AT01-002

SERVICE BULLETIN

## 2002 Q45 A/T SHIFT LEVER DIFFICULT TO MOVE

**APPLIED VEHICLES:** 2002 Q45 (F50) with Automatic Transmission

Figure 2

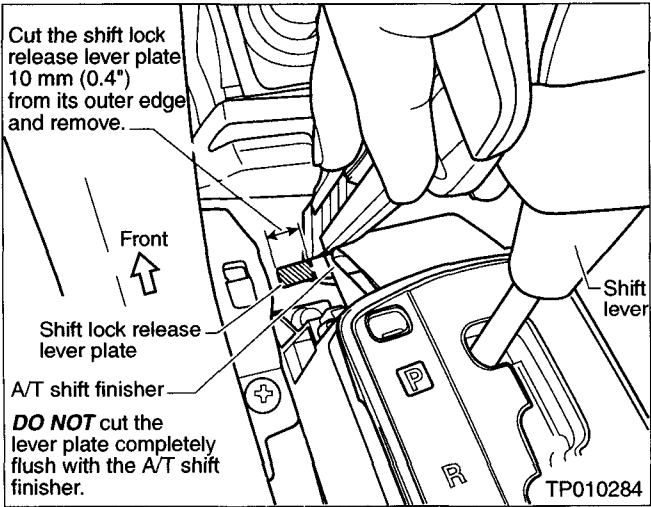
3. Locate the shift lock release lever plate (white plastic piece). See Figure 2.

4. Cut the shift lock release lever plate 10 mm (0.4 inch) from its outer edge and remove.

**CAUTION:** DO NOT cut the lever plate completely flush with the A/T shift finisher (see Figure 2).
